RE: Addendum #2 to the Issued for Bid Package

This Addendum forms a part of the Contract Documents and modifies the original Issued for Bid package dated February 27th, 2023.

PRE-BID QUESTIONS AND ANSWERS

PROJECT: **RSU 56 BUS GARAGE**
DIXFIELD, ME
FOR:

SUBSURFACE WASTEWATER DISPOSAL PLAN

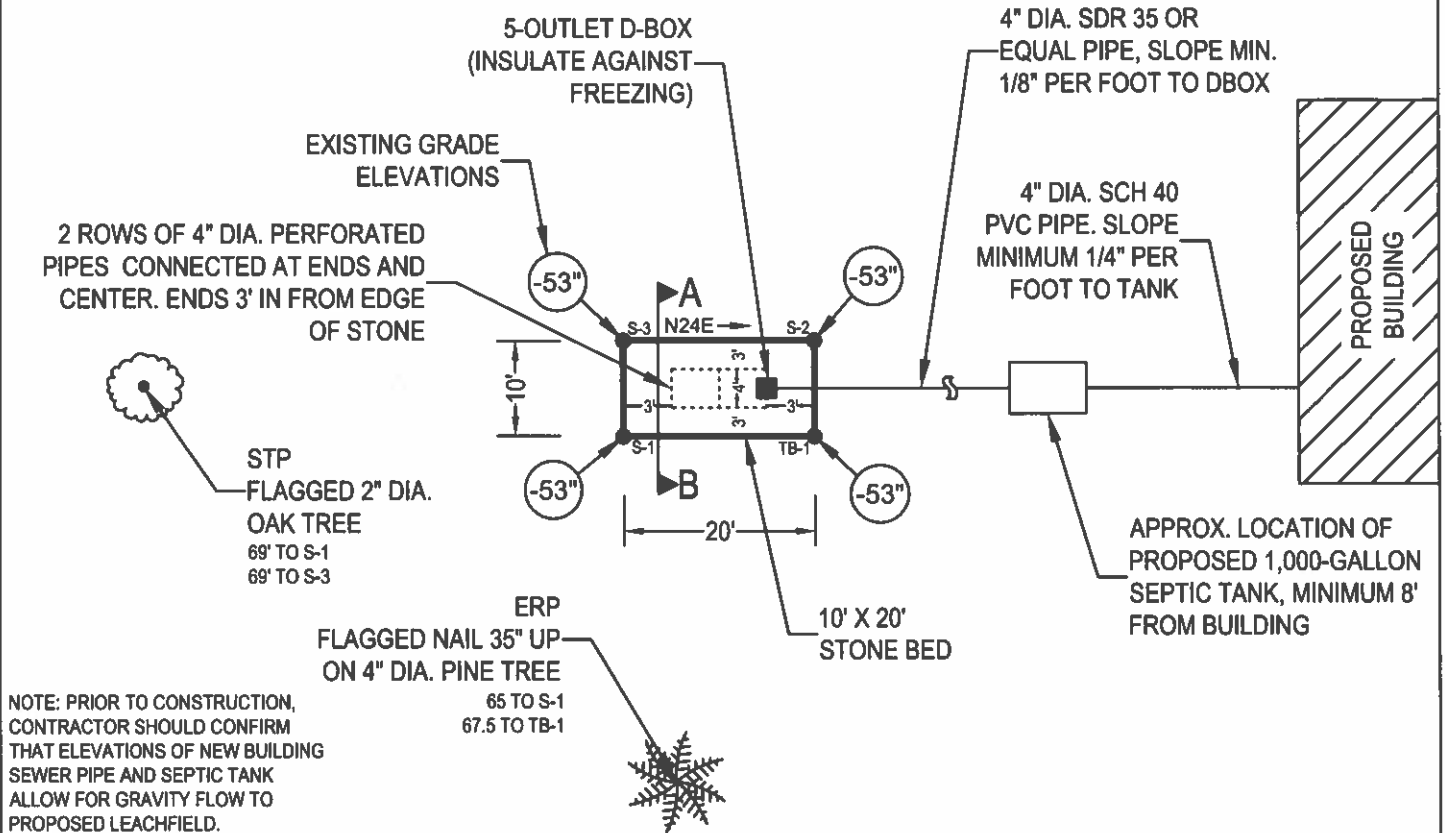
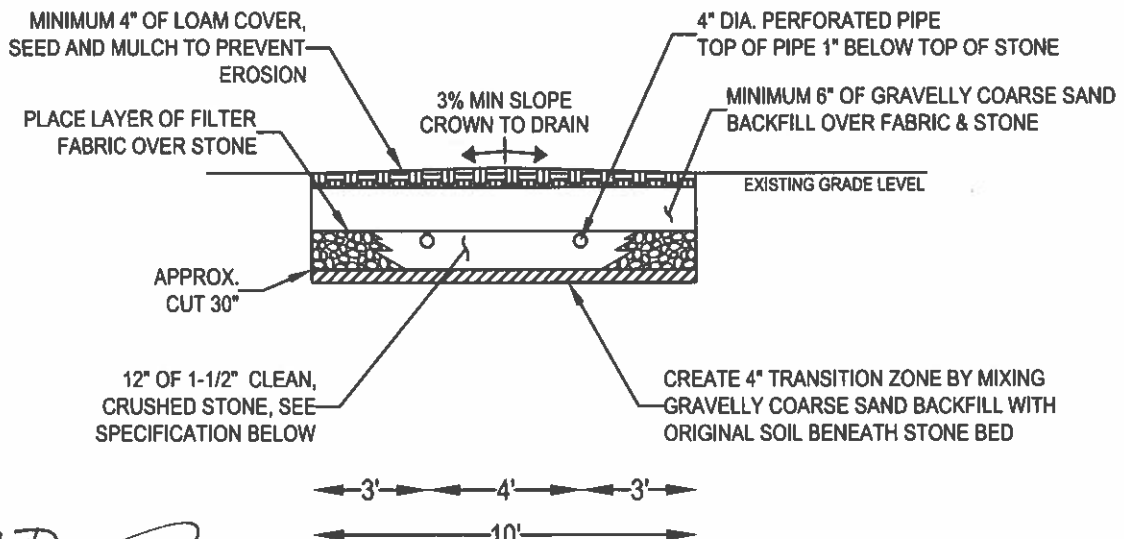
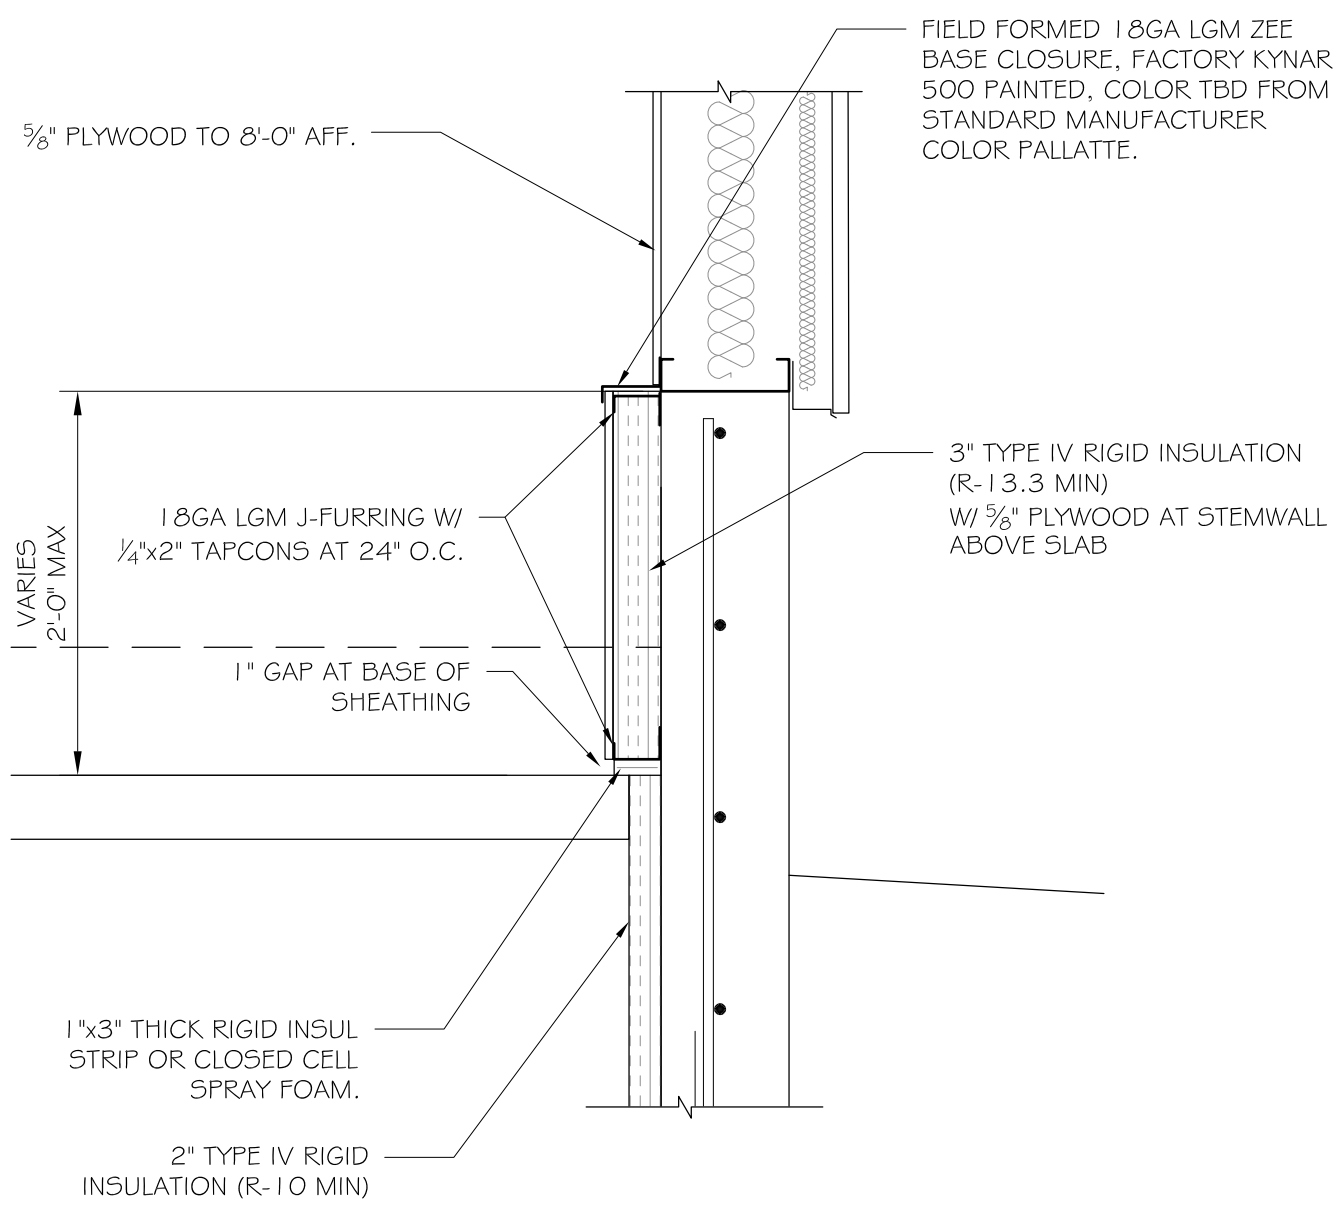
Q: Please forward the HHE-200 report for the septic design referenced on C2.1 Site Plan.

A: See HHE-200 (attached) .

DRAWING NO. **C1.1**

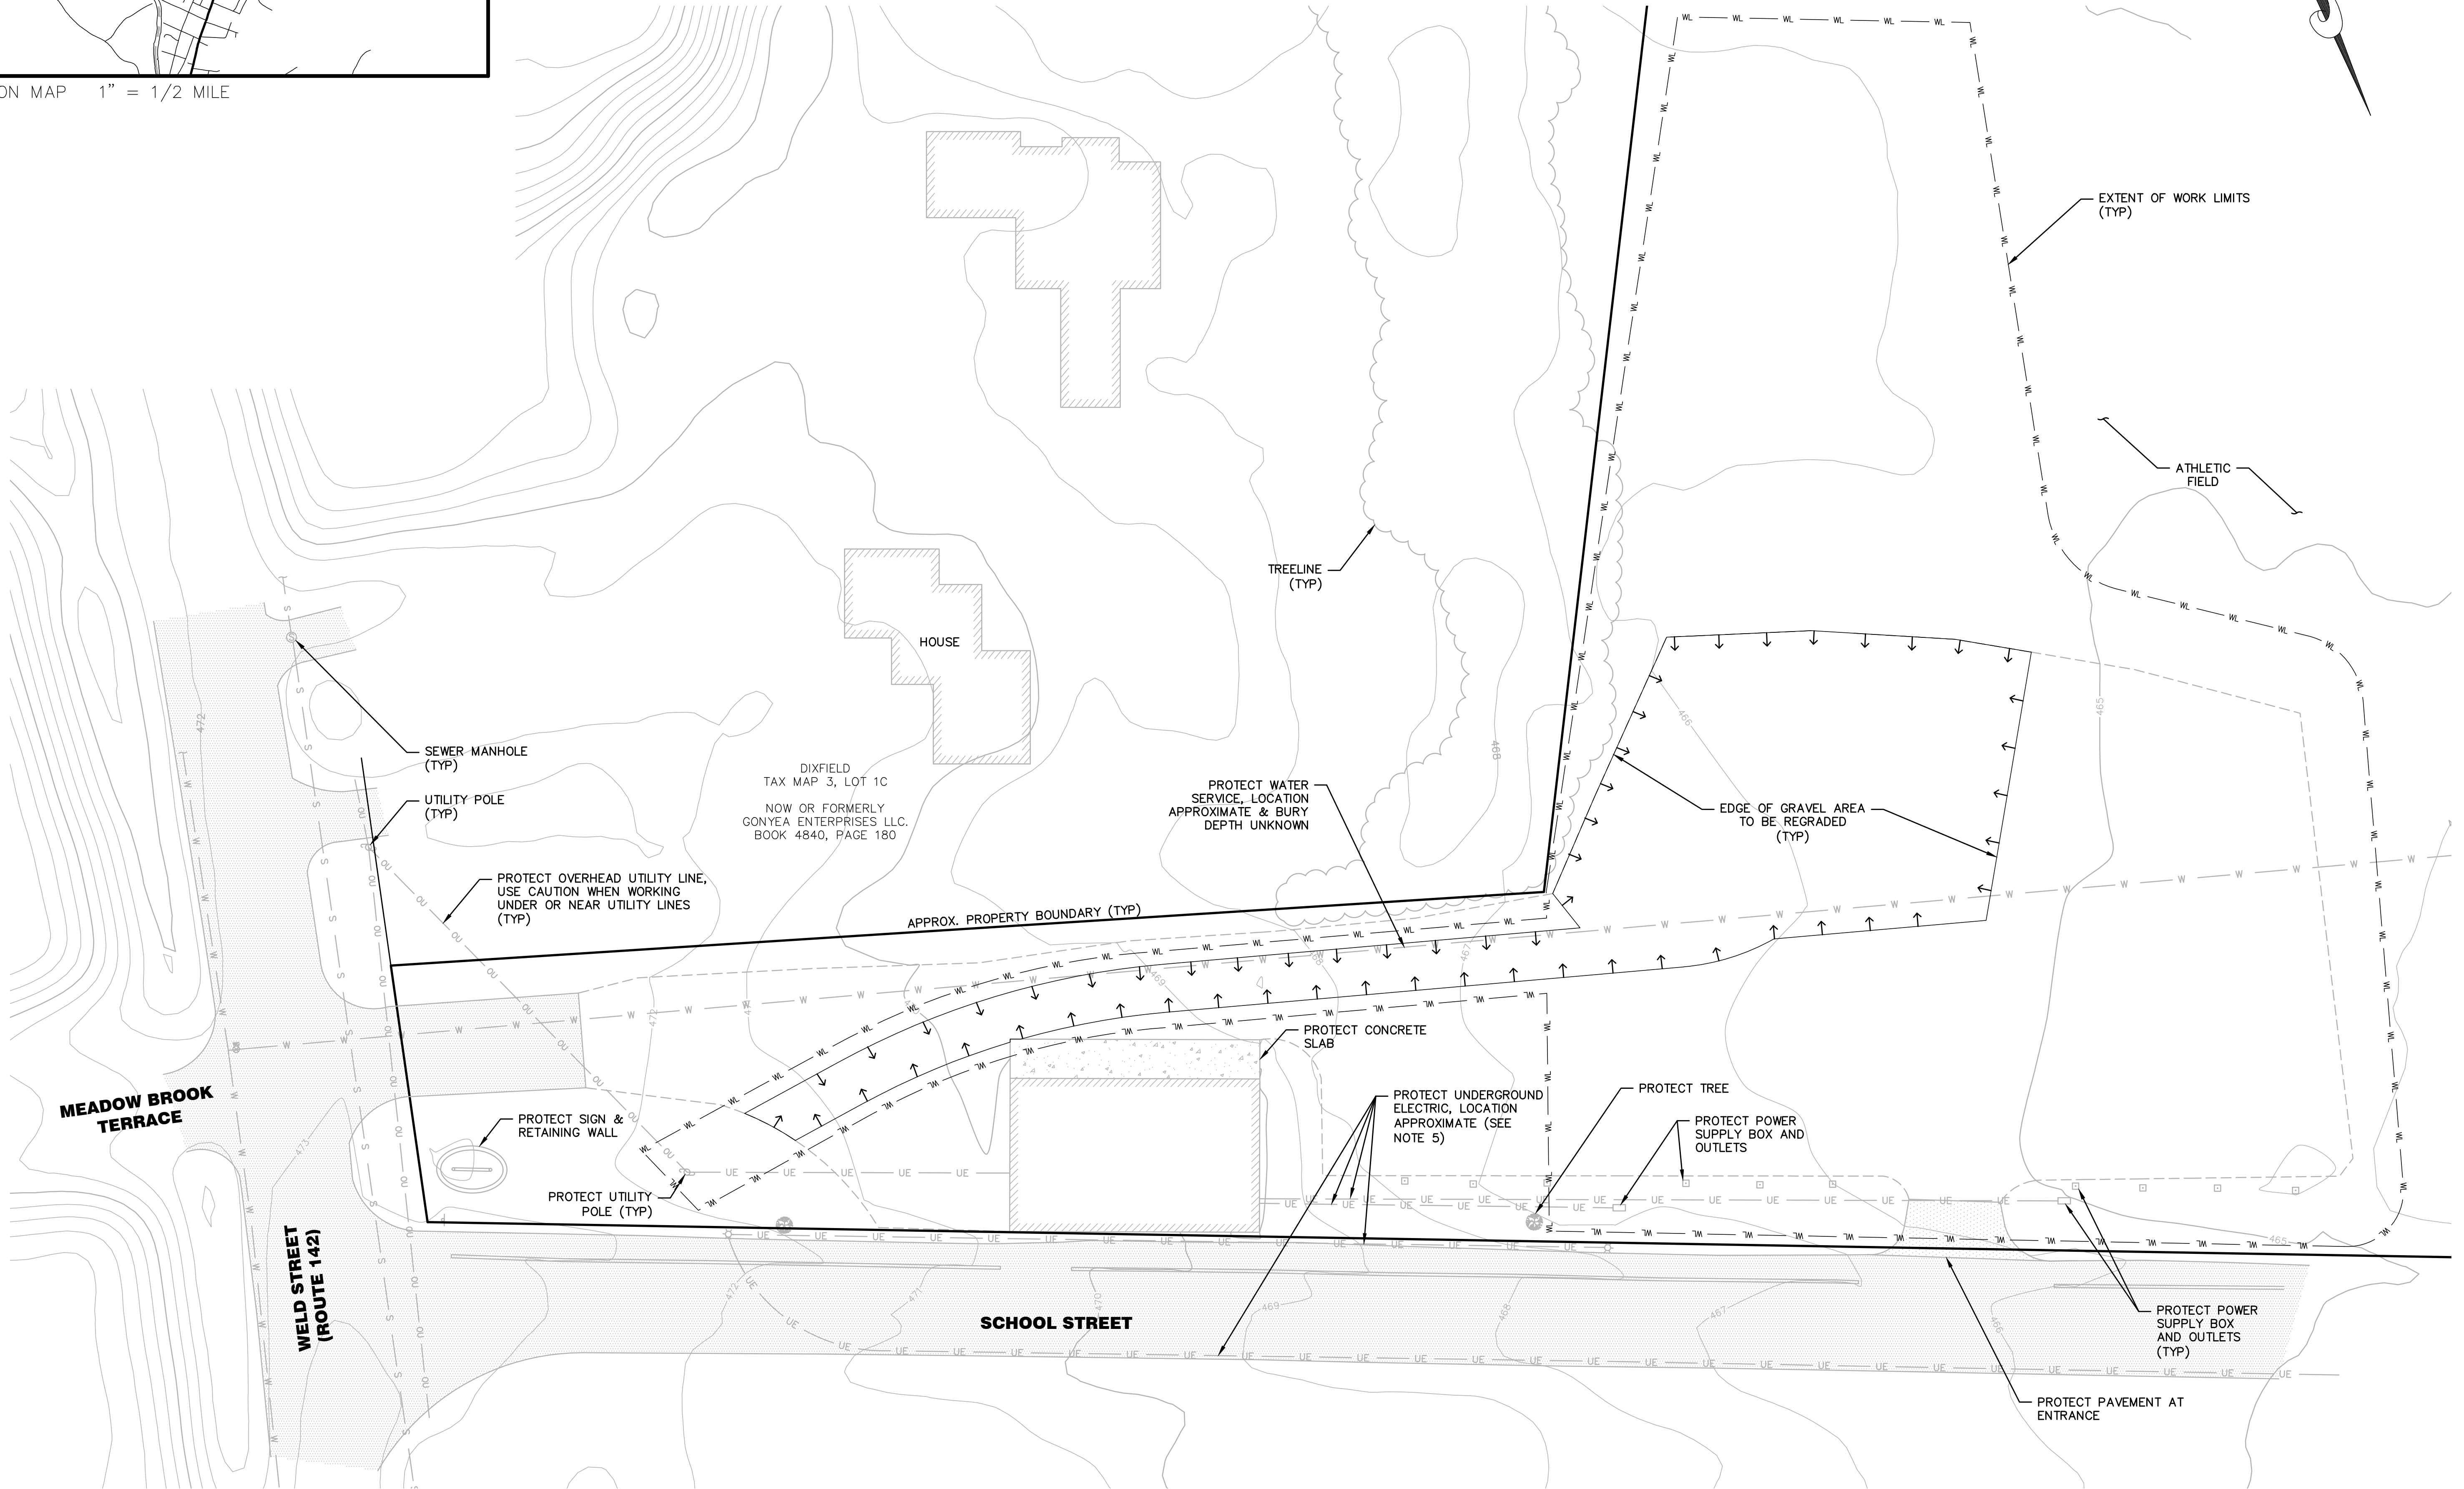
1. Civil Drawings C1.1 and C2.1 revised with new underground electric/fiber conduit location.
2. Drawing A2, Section A1 revised.
3. HHE-200 Report added to bid documents.
4. SK-1 added to bid documents.

SUBMISSION 3: 2023-03-10 TLB ISSUED FOR BID. REVISED PROPOSED UNDERGROUND ELECTRIC LINE LOCATIONS.
